DETERMINATION OF DEVELOPMENT APPLICATION BY GRANT OF CONSENT

Development Application No: DA237/2022/2

Development: Demolition of the existing dwelling and construction of a

Site: 144 Bellevue Road, Bellevue Hill (Lot 1 DP981550)

Diagram 1 – Extent of privacy treatment required to select windows as indicated in red and described under Condition C.1(c). The privacy screens circled in yellow are to be deleted.

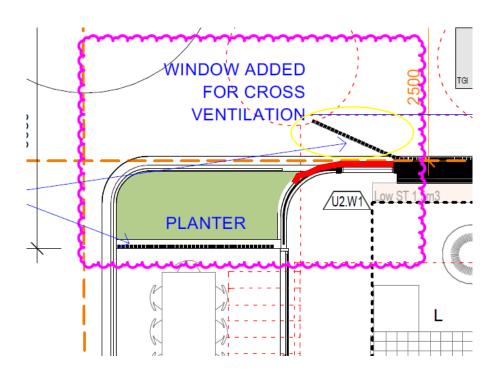
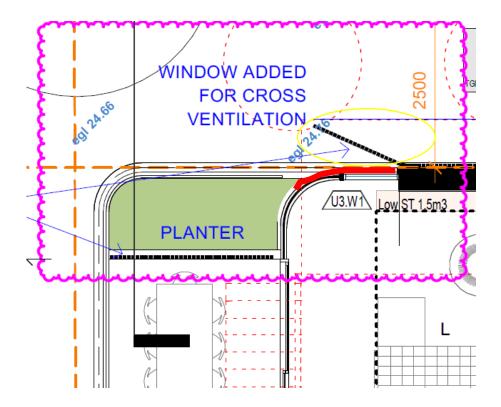
- a) The Stormwater Plans are to be amended so that the location of the A-1 pump-out holding pit is installed no closer than 2.5m of the trunk of tree No.5.
- b) Amended Landscape and Architectural Plans are required to ensure consistency with the amended Stormwater Plan as conditioned to be prepared.
- c) In order to protect the privacy of the adjoining property and to comply with Part 3F: Visual Privacy of the Apartment Design Guide, externally fixed privacy screening to a height of at least 1.5m above the finished floor level of Units 2 and 3 is required along the western façade to Windows U2.W1 and U3.W1 for the extent shown in red in Diagram 1 below. The privacy screens circled in yellow on Diagram 1 are to be deleted. Privacy screening must not project more than 150mm beyond the walls and windows, in order to minimise any encroachment into the side setback.
